## Certification Labels - Incorrect GAWR Information

<b>Bulletin Type:</b>	Recall	<b>Publication Date:</b>	October 2024
<b>Bulletin #(s):</b>	24V-751 US 2024-594 Canada	<b>Make(s):</b>	Jayco
<b>Job Code(s):</b>	9901613	<b>Model(s):</b>	Jay Feather Air TT
<b>Flat Rate(s):</b>	9901613 - 0.3 Hr. Labor - Replace Certification Label	<b>Model Year(s):</b>	2025

Certification Label

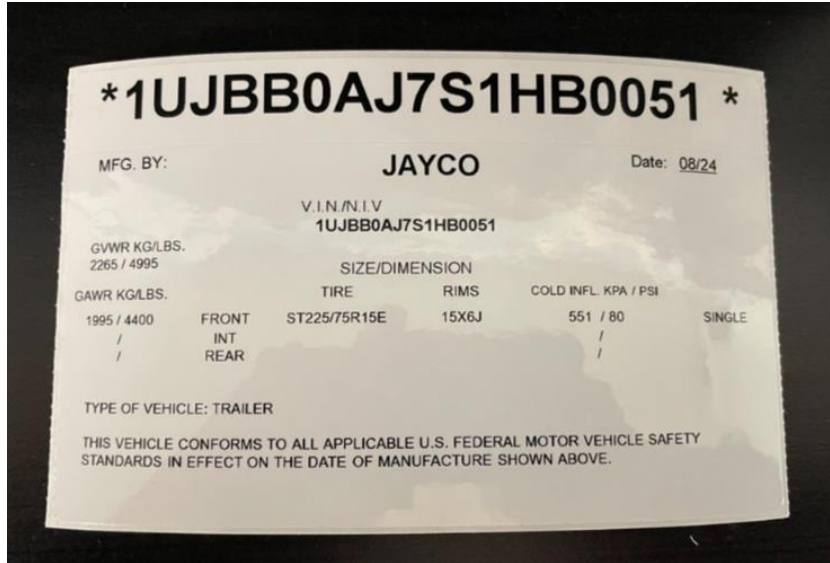
<b>Incident:</b>	Certification labels have the incorrect GAWR listed. The label should list the capacity as 1995 kg (4400 lb.) instead of 2333 kg (5145 lb.)
<b>Affected Units:</b>	2025 Jayco Jay Feather Air TT
<b>Part:</b>	Part: Certification Label enclosed in owner/dealer notification letter
<b>Misc. Tools &amp; Supplies:</b>	Isopropyl alcohol Shop rag
<b>Parts Return Information:</b>	N/A

1. Travel trailer models locate the certification label on the off door side front of unit.
2. Remove the existing label. Using isopropyl alcohol and a shop rag, remove any adhesive residue from the surface where the original label was removed.
  - a. Allow the area to dry for at least 30 seconds.

1. Remove the protective back from the new label. Align the new label in the same location of the original label and apply it to the surface. Remove any air bubbles from the label.
  - a. **Note:** Do not attempt to remove or adjust the label once it has touched the surface. Doing so may damage the label or cause it not to adhere properly to the surface.
